UNITED STATES PATENT AND TRADEMARK OFFICE

APPLICATION NO.	FILING DATE	FIRST NAMED INVENTOR	ATTORNEY DOCKET NO.	CONFIRMATION NO.
10/574,694	03/05/2007	Jouni Matula	JHN-5373-5	3738
23117 7590 01/31/2011 NIXON & VANDERHYE, PC 901 NORTH GLEBE ROAD, 11TH FLOOR ARLINGTON, VA 22203				
EXAMINER JANCA, ANDREW JOSEPH				
ART UNIT		PAPER NUMBER		
1774				
MAIL DATE		DELIVERY MODE		
01/31/2011		PAPER

Office Action Summary

DETAILED ACTION

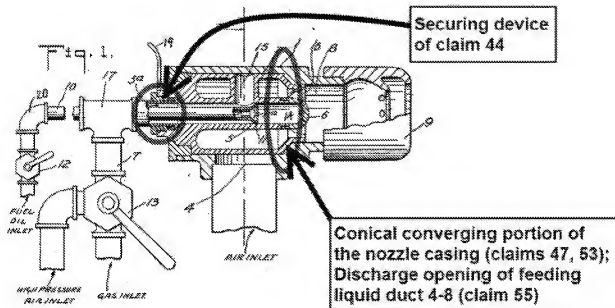
19. With regard to claim 44, Clements discloses the feeding device according to claim 35, further comprising a securing device, the unnumbered ring to which valve handle 19 is attached (see figure 1 as annotated below), that secures the mixing liquid feed duct 7-5a-5-6 to the nozzle casing 1 so that a [angular] position of the mixing liquid

feed duct can be adjusted: rotating 19 adjusts the angular position of sleeve valve 2 forming part of the body of the mixing liquid feed duct 7-5a-5-6 (figures 1-4; 1:37-46, left column).

22. With regard to claim 47, Clements discloses the feeding device according to claim 35, further comprising a conical converging portion in the nozzle casing 1 defining a converging cross-sectional area of a flow path of the feeding liquid to increase a flow velocity of the feeding liquid (figure 1, annotated above).

28. With regard to claim 53, Clements discloses the feeding device of claim 52 wherein the nozzle casing 1 includes a converging casing section which forms a converging section of the flow path for the feeding liquid (figure 1, annotated above).

30. With regard to claim 55, Clements discloses a feeding device which may be used for feeding a chemical into a process liquid flowing through a process liquid flow duct 8-9, the feeding device comprising: a feeding liquid duct 4-8 including a discharge opening (see figure 1 as annotated above) capable of discharging a feeding liquid to the process liquid; a mixing liquid feed duct 7-5-5a-6 extending through the feeding liquid duct and the mixing liquid feed duct is capable of passing a mixing liquid, wherein the mixing liquid feed duct includes an sidewall 5-6 and an end wall, the closed tip of 6 (figures 1, 3), wherein the end wall extends beyond the discharge opening of the feeding liquid duct 4-8 and extending into the process liquid flow duct 8-9; a mixing space 14 in the mixing liquid feed duct, wherein the mixing space is adjacent the end wall and within the sidewall 5-6 of the mixing liquid feed duct; a chemical feed duct 10 extending through the mixing liquid feed duct and having a discharge opening 11 proximate to the mixing space in the mixing liquid feed duct, wherein the chemical flows through the chemical feed duct and enters the mixing space to form a mixture of the chemical and the mixing liquid, and a mixture discharge opening, one or more apertures at the end of 6, in the side wall 5-6 of the mixing liquid feed duct, wherein the mixture discharge opening is configured to discharge the mixture of the chemical and the mixing liquid from the mixing space into the mixing liquid flowing into or from the discharge opening of the feeding liquid duct 4-8 (figures 1, 3; 1:36 left column forward). Regarding
